DEPARTMENT OF TRANSPORTATION

Anthropomorphic Test Devices; Hybrid III 5th Percentile Female Test Dummy, Alpha Version; Final Rule; Response to Petitions for Reconsideration

ACTION: Final rule; response to petitions for reconsideration.

FIGURE O1
NECK FLEXION TEST SETUP SPECIFICATIONS

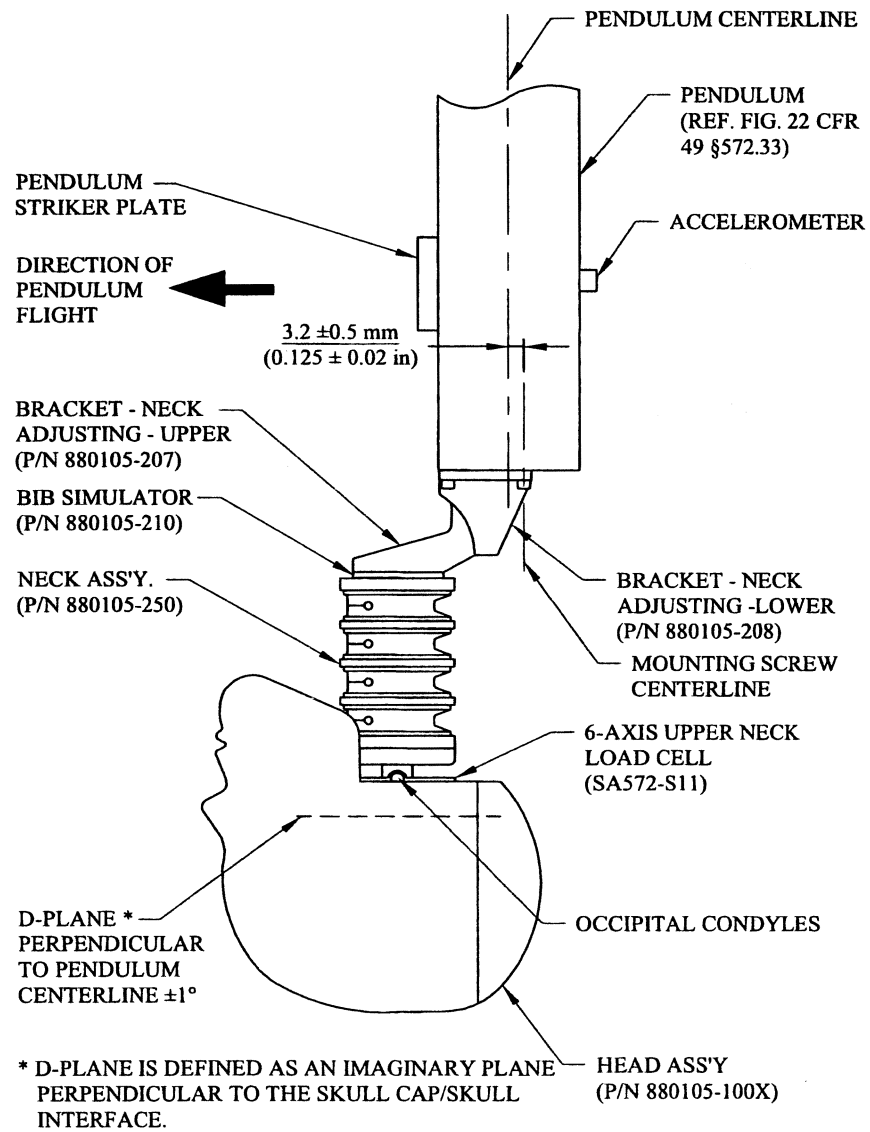
The Alliance noted that Figure O1 (*Neck Flexion Test Setup Specifications*) is missing the label for the lower neck-adjusting bracket. The Alliance also noted that the second label for the neck-adjusting bracket in Figure O2 (*Neck Extension Test Setup Specifications*) is incorrect. It should read: "BRACKET—NECK ADJUSTING—UPPER (P/N 880105-207)."

NHTSA agrees with all of these recommendations. The suggested changes reflect errors in the figures. Accordingly, the agency is revising Figure O1 by adding the missing label for the lower neck-adjusting bracket. That label will read "BRACKET—NECK ADJUSTING—LOWER (P/N 880105-208)." The agency is also revising the second label for the neck-adjusting bracket in Figure O2 to read: BRACKET—NECK ADJUSTING—UPPER (P/N 880105-207). The agency is changing the tolerance for the test probe alignment in Figure O3 from ± 0.05 degrees to ± 0.5 degrees, and the tolerance for the impact probe weight in Figures O3 and O5 from ± 0.01 kg (0.02 lb) to ± 0.023 kg (0.05 lb). Finally, the agency is adding the angle 7 ± 2 degrees from the horizontal to the note Pelvic Angle Reference Surface in Figure O3.

FIGURE O4
TORSO FLEXION TEST SET UP SPECIFICATIONS

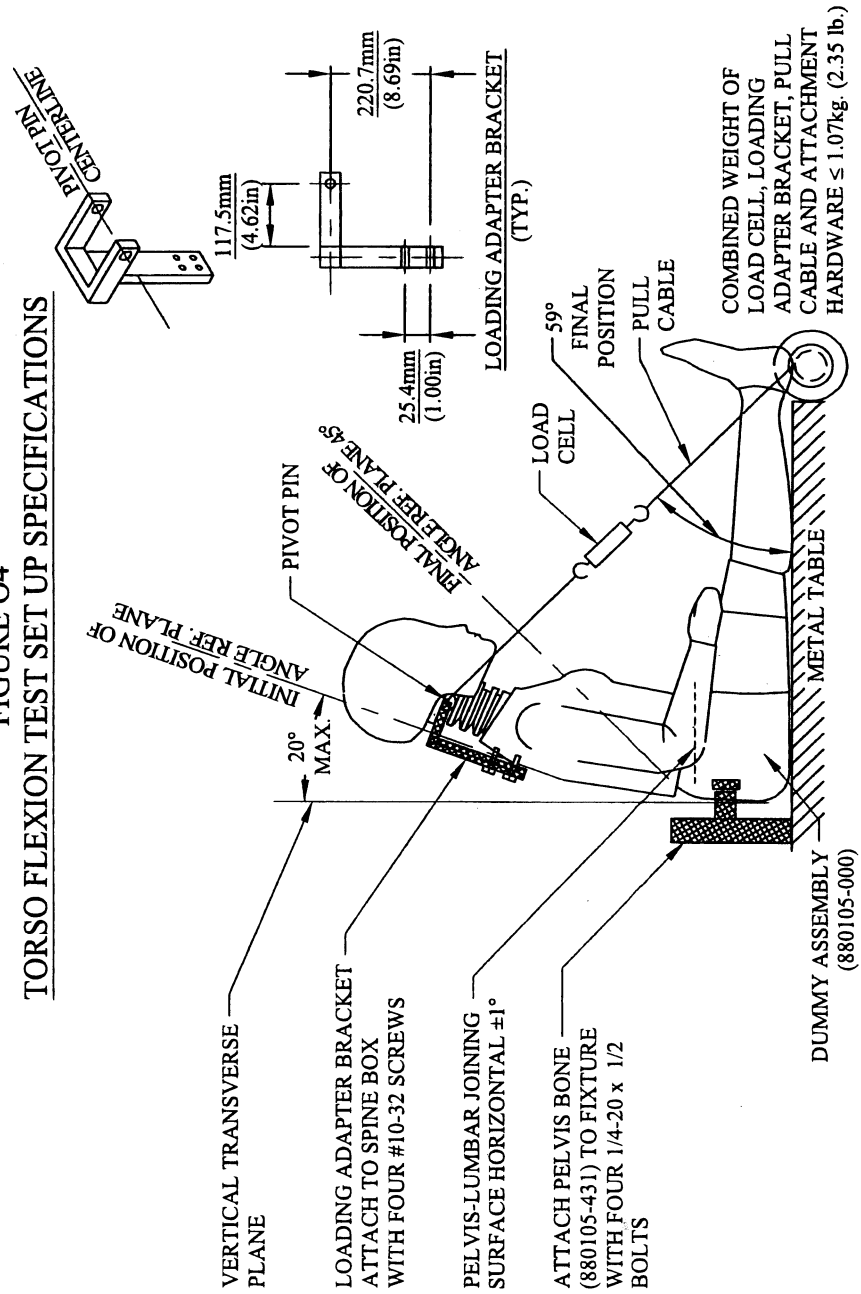
In reviewing Figure O4, NHTSA discovered that it had failed to specify the weight of the pull mechanism⁷ used in the torso flexion test. The Hybrid III Six- and Three-Year-Old dummy requirements each specify the weight of the pull mechanism for the torso flexion test. To be consistent with those dummy requirements and assure test repeatability, the agency is specifying that the weight of the pull mechanism must be less than or equal to 1.07 kg (2.35 lb).

Accordingly, the agency is adding the following note to Figure O4: "Combined weight of load cell, loading adaptor bracket, pull cable, and attachment hardware 1.07 kg (2.35 lb).

FIGURE 03
THORAX IMPACT TEST SETUP SPECIFICATIONS

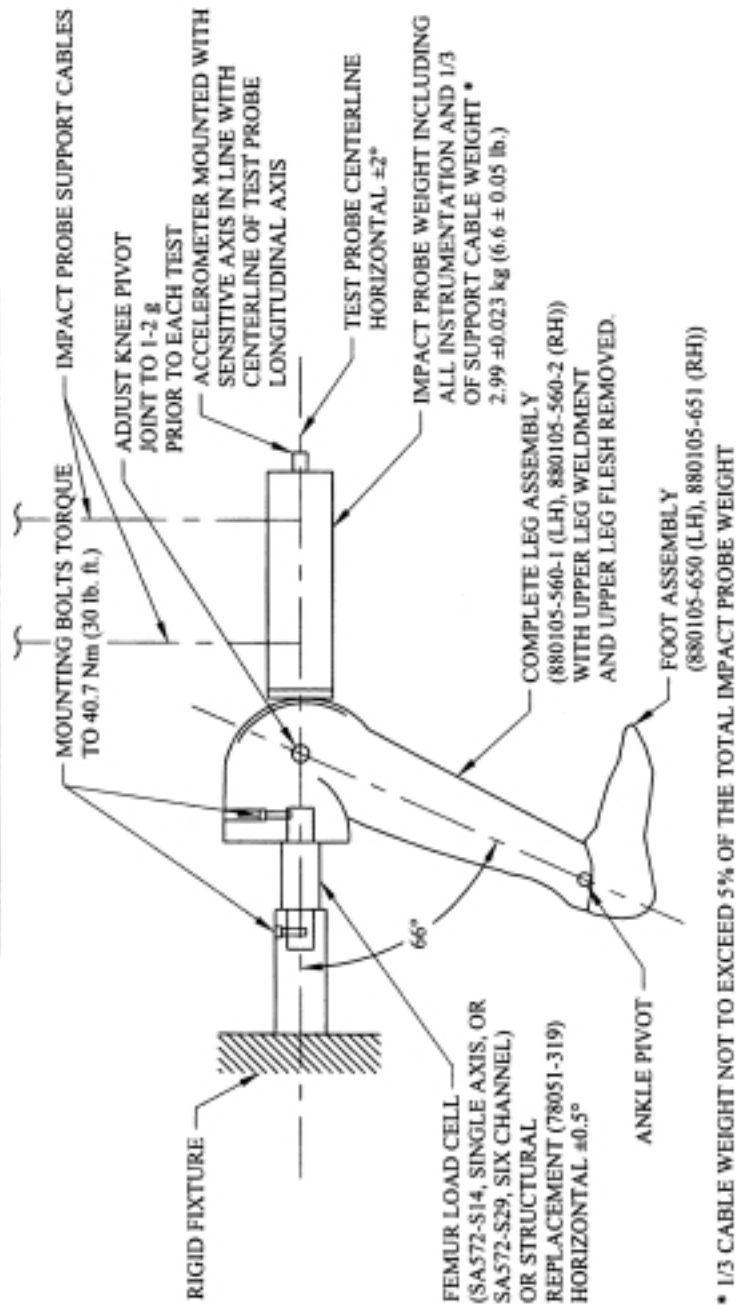
The Alliance and FTSS noted that some of the language in Figure O3 (*Thorax Impact Test Setup Specifications*) does not conform to the language in the final rule text.

Specifically, the Alliance and FTSS recommended that the agency change the tolerance for the test probe alignment from ± 0.05 degrees to ± 0.5 degrees, and the tolerance for the impact probe weight from ± 0.01 kg (0.02 lb) to ± 0.023 kg (0.05 lb) to conform to the text of the final rule. Finally, the Alliance and FTSS stated that Figure O3 does not contain a pelvic angle measurement. They noted that the Society for Automotive Engineers (SAE) Engineering Aid 25 specifies that the pelvis should be inclined rearward 7 ± 2 degrees with respect to the horizontal. They recommended that this angle be added to the note Pelvic Angle Reference Surface" in Figure O3 so that testers will not be required to force the dummy's pelvis into an unnatural orientation.
